An Bord Pleanála,
64 Marlborough St.
Rotunda,
Dublin 1.

Date 23rd October 2022 Gary Harpur I wish lodge an objection and make observations in relation to the planning application submitted by Dart + West for planning permission for new Railway lines and Depot. The project in its current form (your application reference 314232) is unacceptable and the application is invalid.

Figure 1. Dart + West Proposed CPO at Ballycurraghan with new entrance to Land at Ballycurraghan marked in yellow

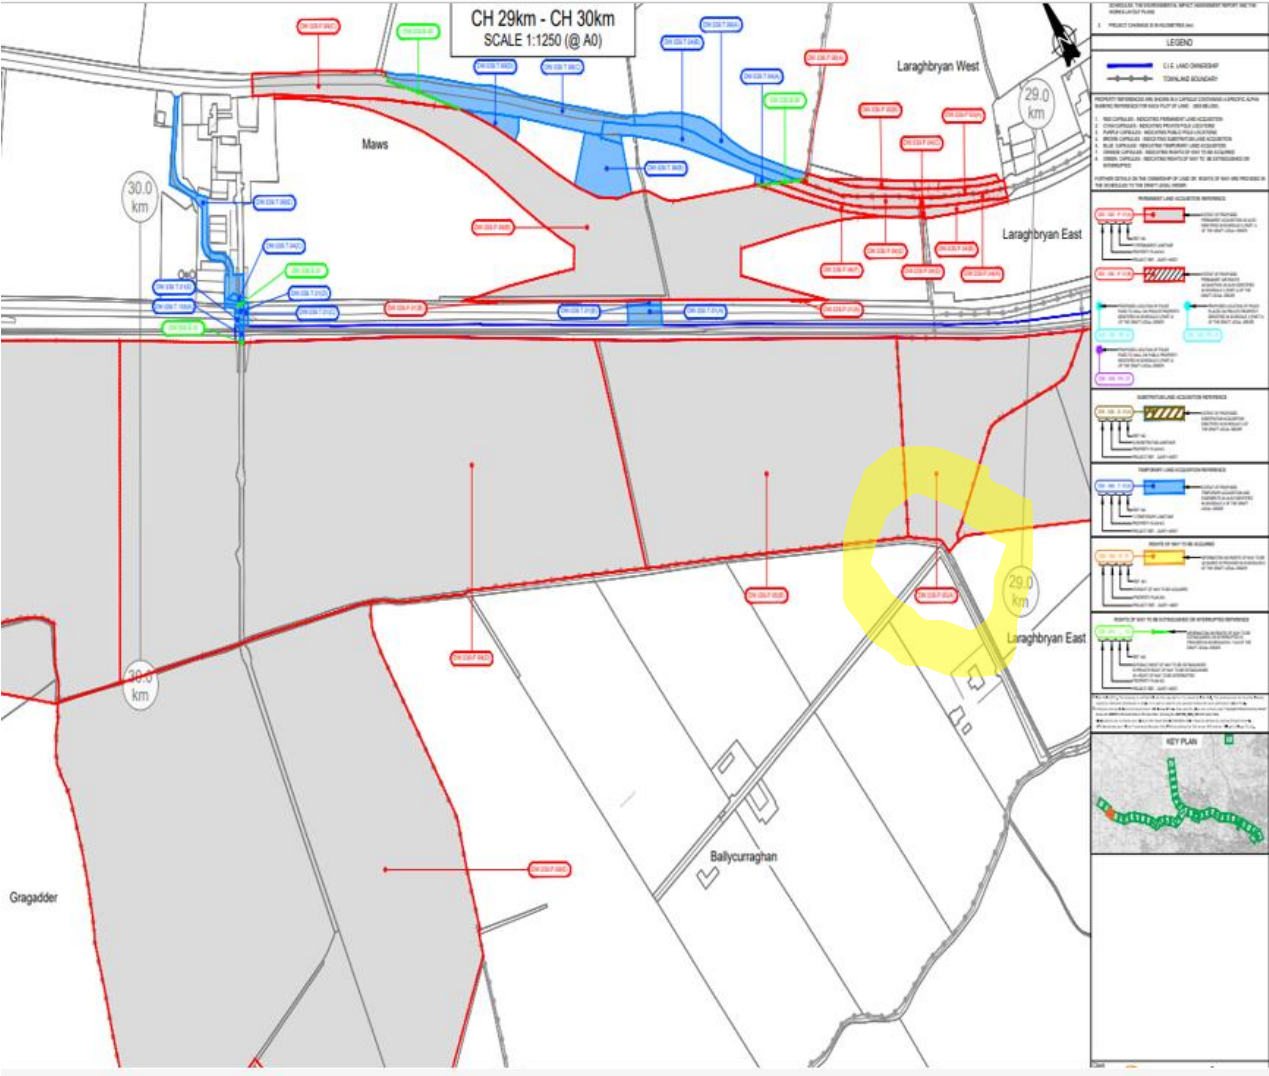
You will see from Figure 1. Below. Dart + West Proposed CPO at Ballycurraghan with new entrance to Land at Ballycurraghan marked in yellow se out below. Figure 2 show a picture of the proposed work at the depot with alteration to private laneway at Ballycurraghan circled in yellow. Clearly this work should have been included as part of the Railway order as private rights of way and private road is being altered. Neither Irish rail or their consultants notified or engage with me in relation to this work . Figure 3 shows Land at Ballycurraghan including right of way over roadway to Ballycurraghan market in yellow with area of proposed alteration and entrance to Laneway marked in blue .

It would appear that the requirement for this new entrance to Ballycurraghan is because the existing lane way will be impassable during flooding and this additional entrance to the Ballycurraghan laneway is required as it will be the only access available to the Residents of L 5041 during flooding

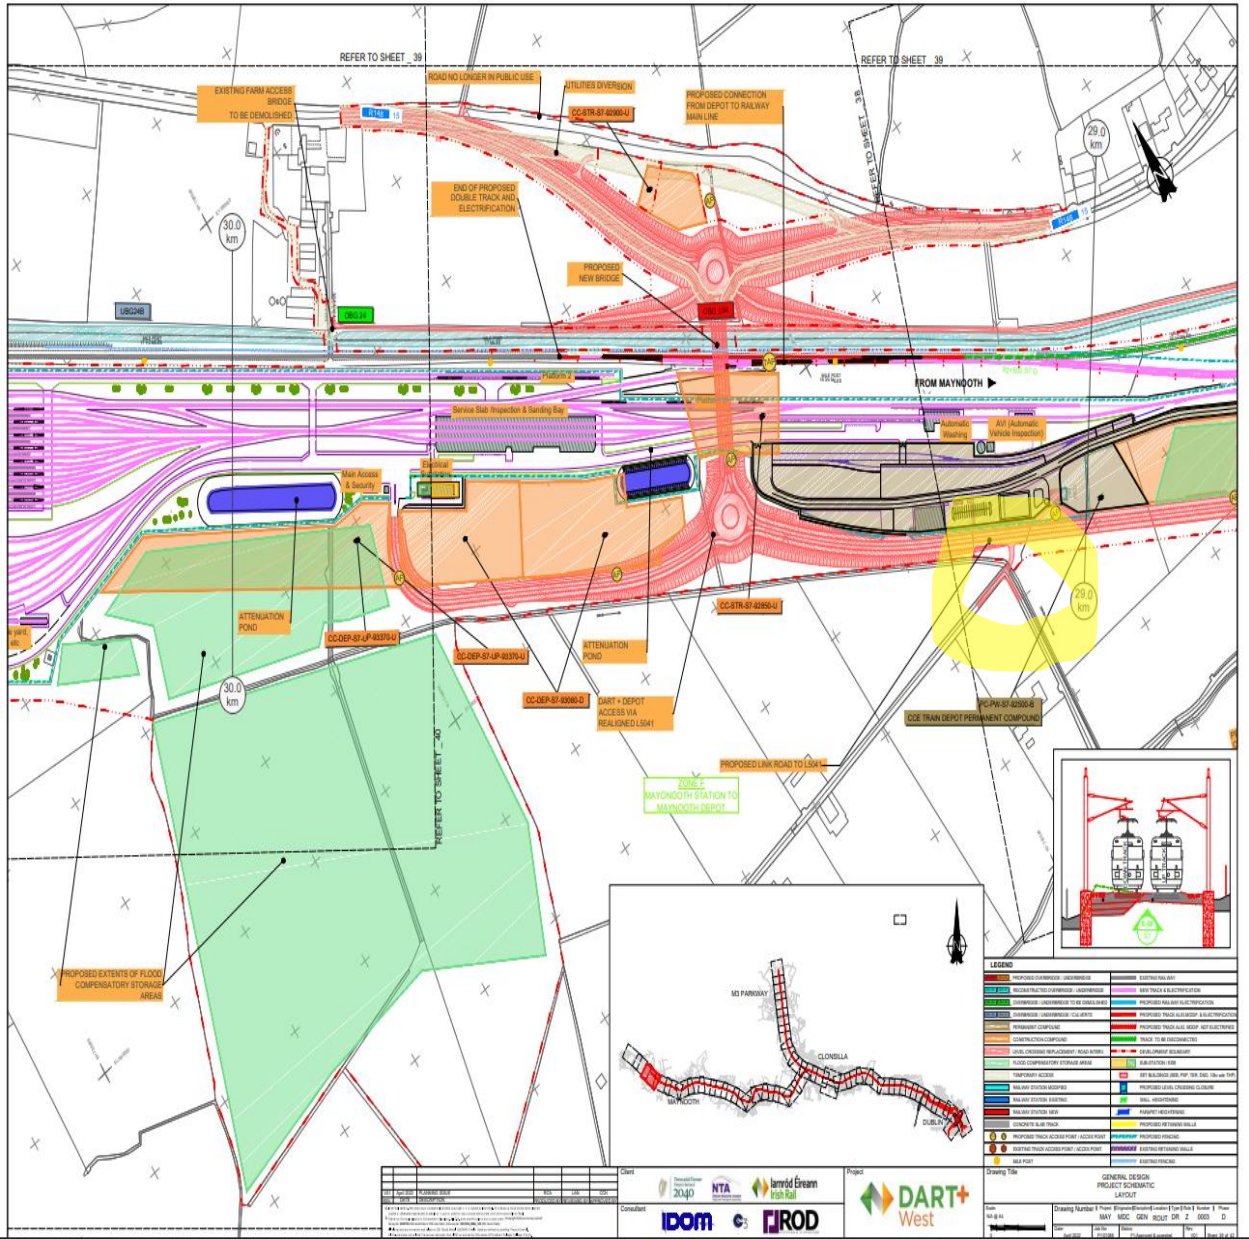
Figure 2 show a picture of the proposed work at the depot with alteration to private laneway at Ballycurraghan circled in yellow. Clearly this work should have been included as part of the Railway order as private rights of way and private road is being altered. Neither Irish rail or their consultants notified or engage with me in relation to this work

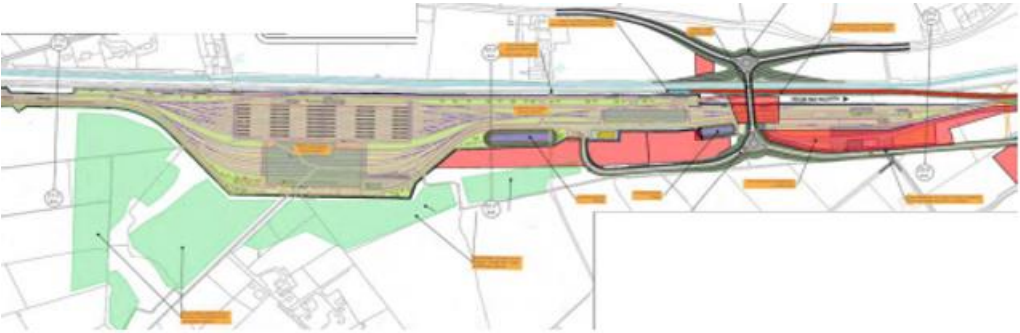
The drawing for depot are not properly complete and doesn't include proper levels . It is not possible to compare the levels of the new works as compared with the existing levels of the surround countryside

Levels at Jacksons Bridge and Train Levels Showing train line actual train level 1.4 m above flood plain average or just below level of hedge.

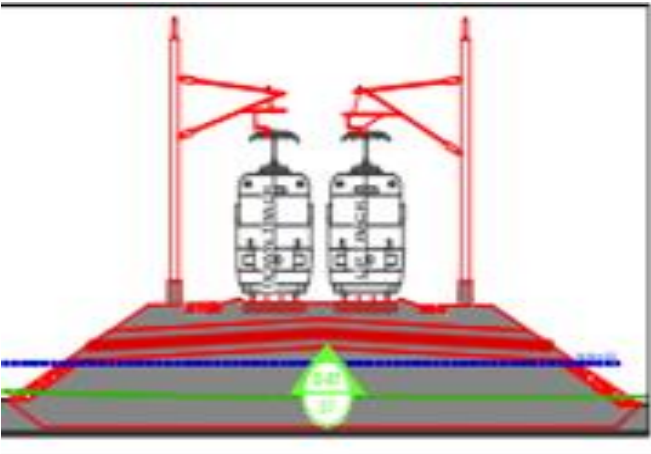
Blue line in picture above represents 60.36 which 1.40 above Ballycurraghan Lane level which is going to visually have a serious effect on the area.

Picture 5 . Receeding Floodwaters at Jacksons Bridge / Ballycurraghan November 2017

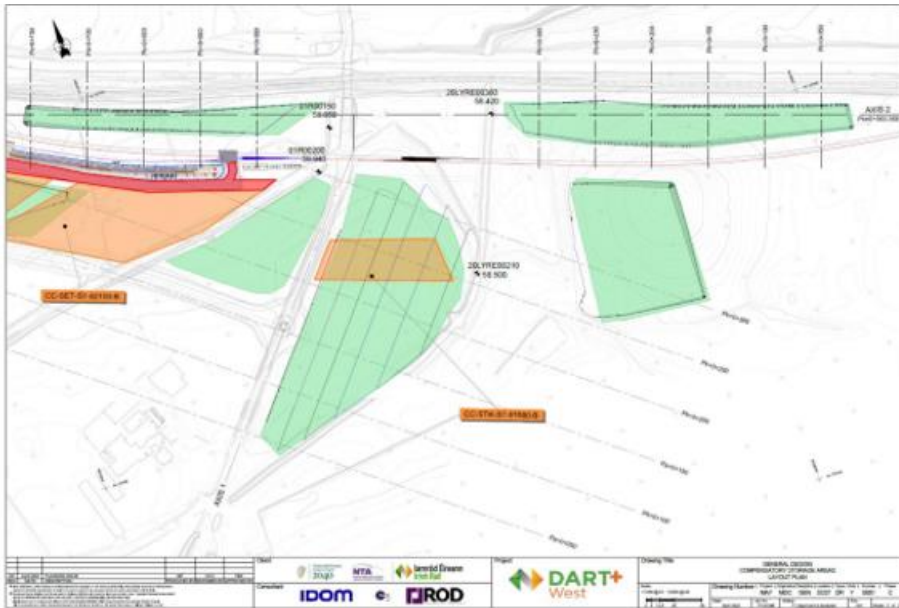
Above please see the area that it is allocated to compensatory flooding capacity. As you can see this area is subjected to severe flooding already. The Water table level is extremely high so any excavation is only going to expose ground water. In my view there will be no additional compensatory flooding capacity provided.

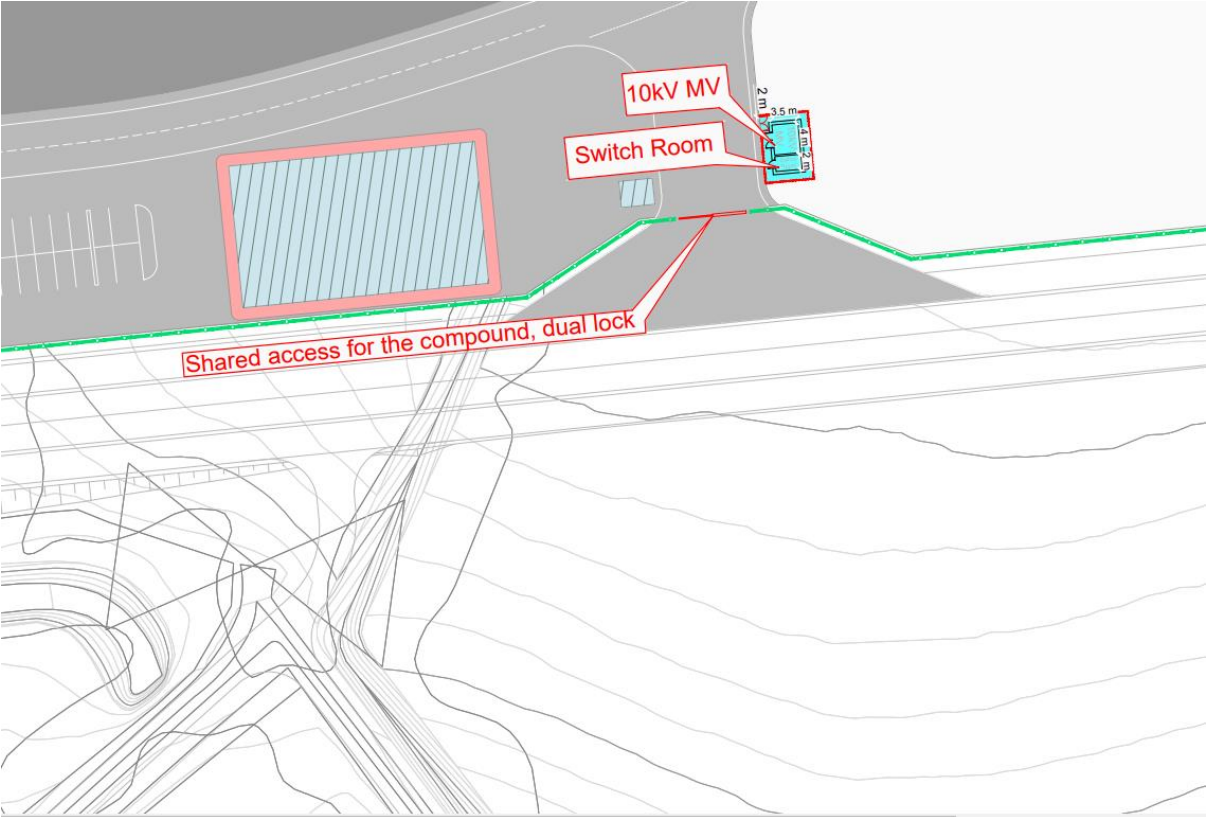
This drawing shown new compound located directly across from new entrance from L5041 to Ballycurraghan.

Figure 5-356 Millfarm compounds and haulage route

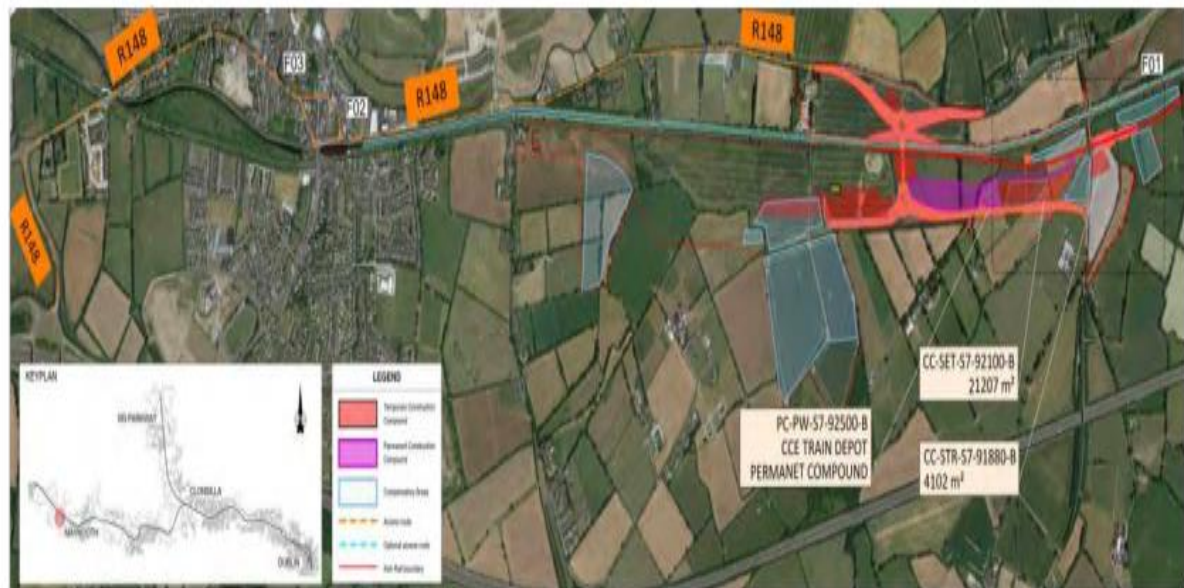
Figure 5-356 Millfarm storage and compounds will be accessed through Kilcock bringing all addition traffic and congestion associated with this to Kilcock. If this project proceeds there is an argument to provide additional access to in both directions M4 from L5041

Alteration to Private Laneway Ballycurraghan

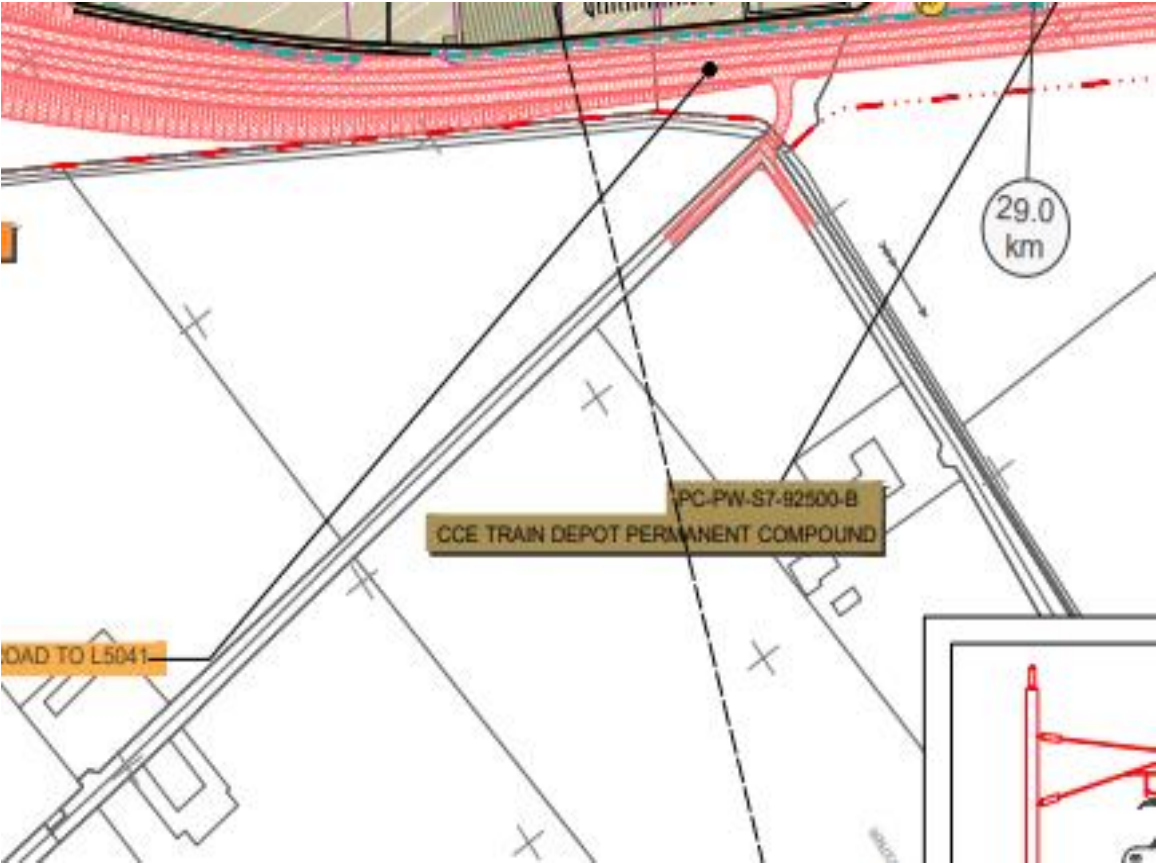
Proposed alteration to private lane at Ballycurraghan in contravention of proper procedure and railway orders

Project	Dart + West project, Maynooth Kildare	Drawing No.	2128_C1003	Date	March 2022
Figure 3 Overall plan of geophysical survey results (grey scale image), field 1 to 20				Scale	1:8,500 @ A3

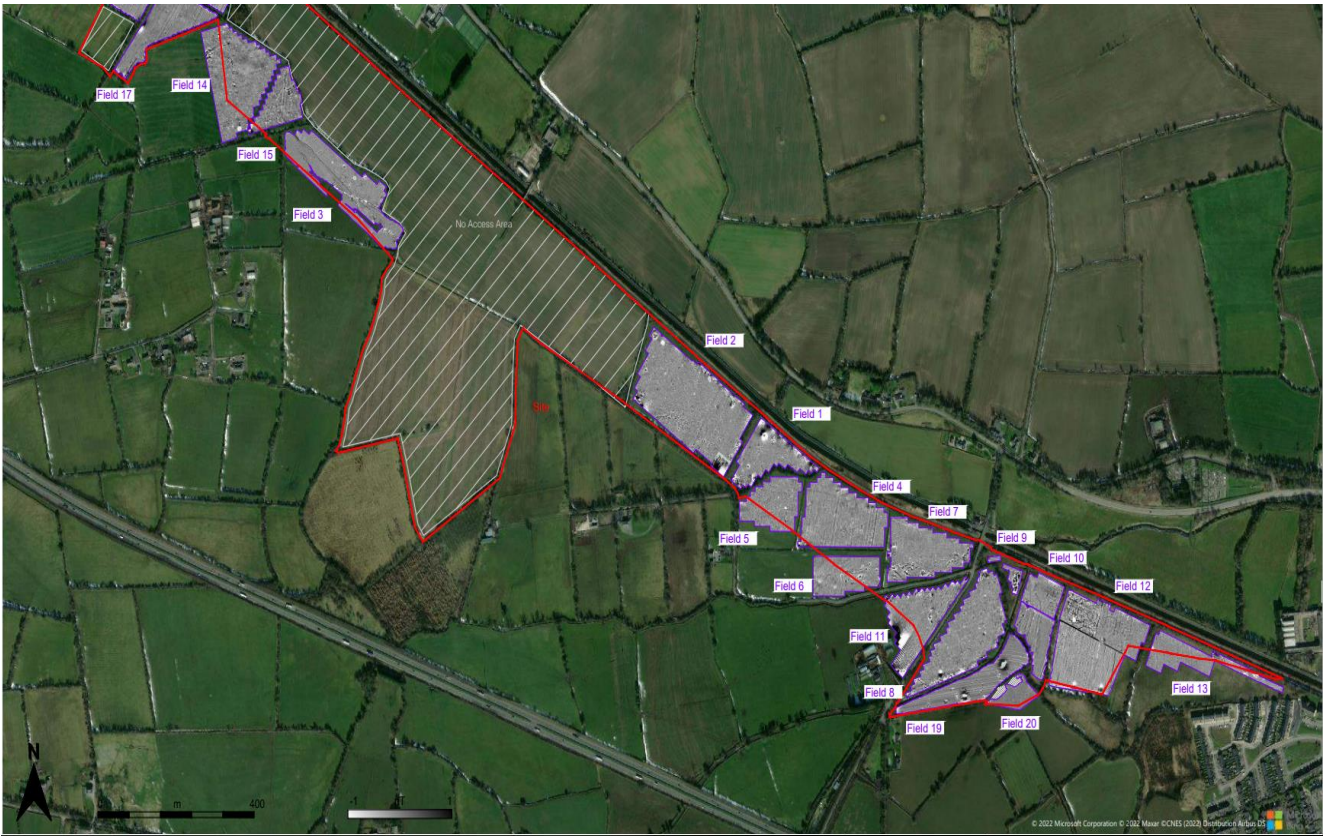
It's important to note here that the proposed Entrance to Ballycurraghan from link road L 5041 has not identified the cut-stone bridge and large tracts of the proposed depot site have not been investigated at all.

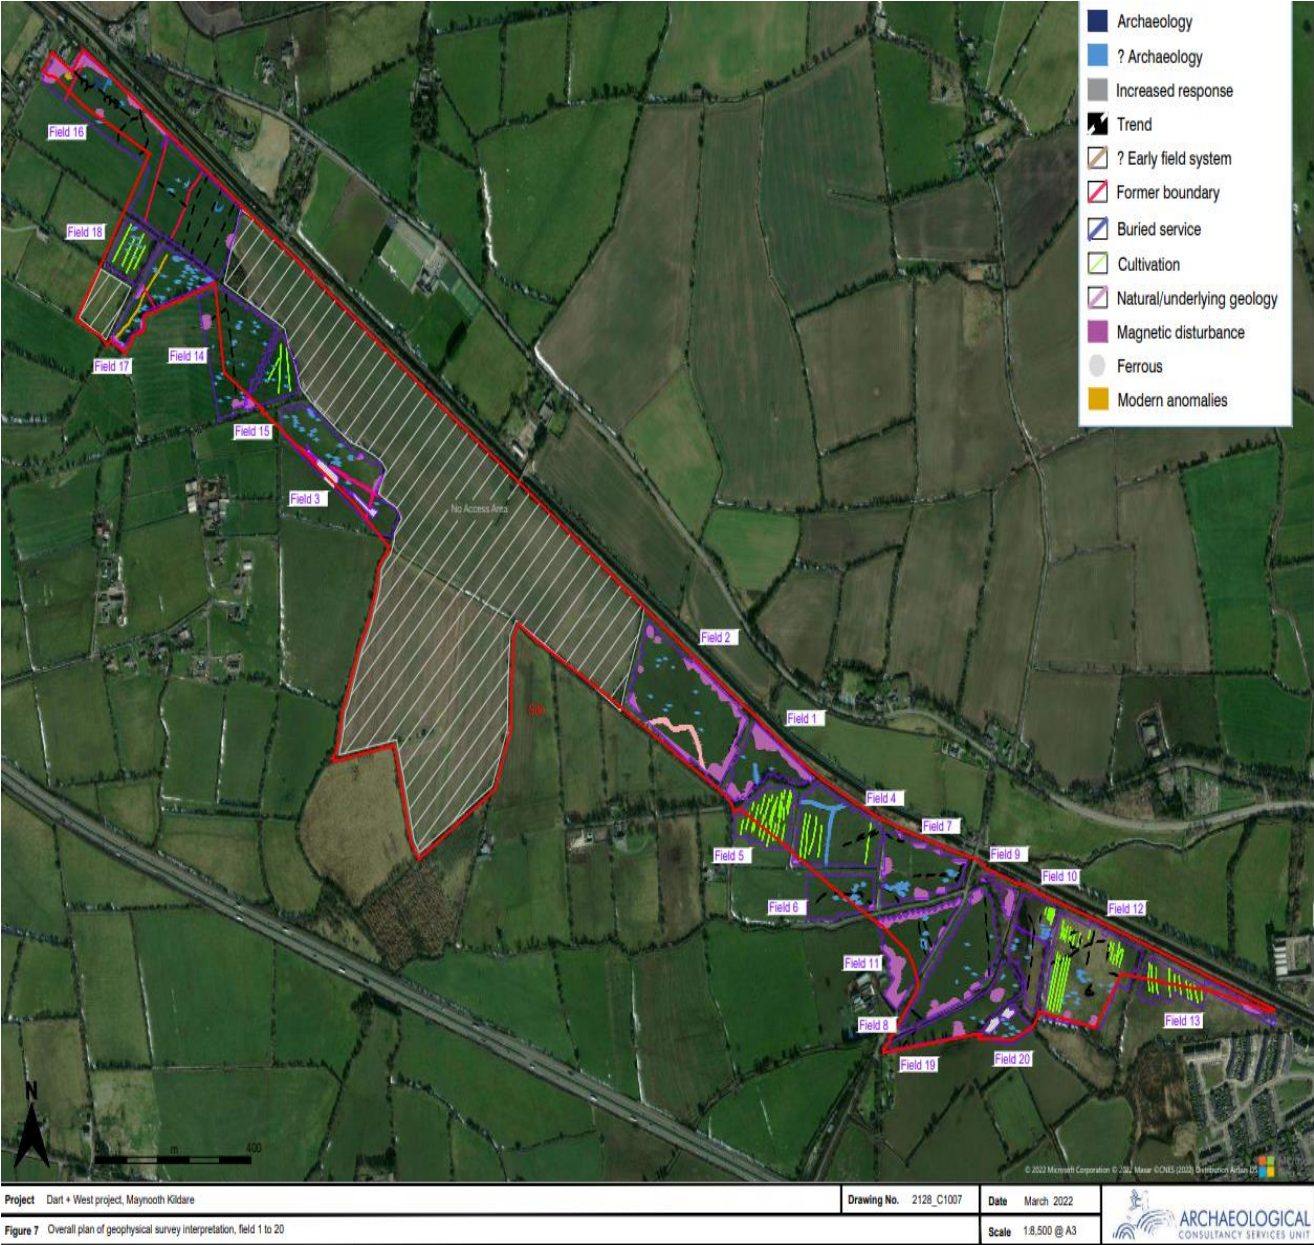
This plan shows the significant area around the depot which has not been investigated at all quoting reason for saying has no access.

Here we can clearly see almost 100 acres of the proposed site has not been inspected or investigated

Levels at Jacksons Bridge and Train Levels Showing train line actual train level 1.4 m above flood plain average.

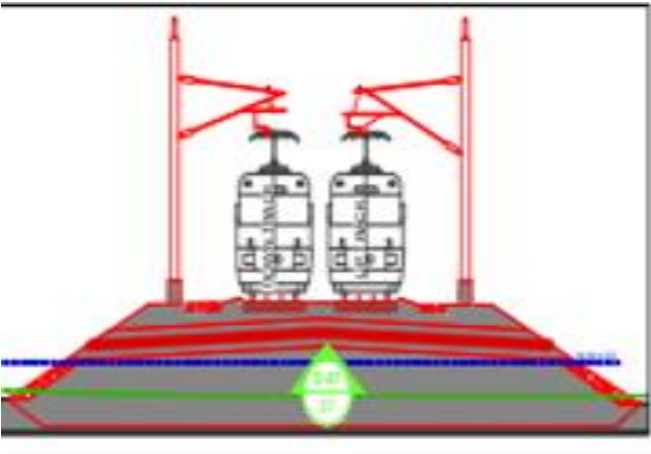
Blue line in picture above represents 60.36 which 1.40 above Ballycurraghan Lane level.
